Access Compliance Report
Public Rights-of-Way
(Pedestrian Signals)

Intersection ID: N/A	Main Street:		Cross Street: N/A		Location: N/A

ADA ID: 0BD1629E1E5B **Signal Type:** One Push Button-Non APS **Overall Compliance:** No **Severity Score: BTN 1:** N/A **BTN 2:** N/A **No BTN:** N/A

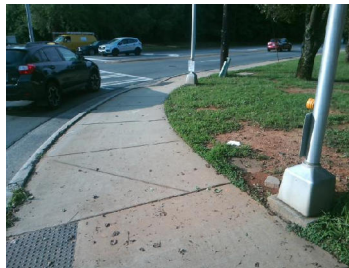
Possible Solutions: Replace Signal Push Button With APS Button on New Post. Remove & Relocate Sign.

PROW/ADA: TMUTCD 4e.08, R404.2, R406.2, R404.7.3
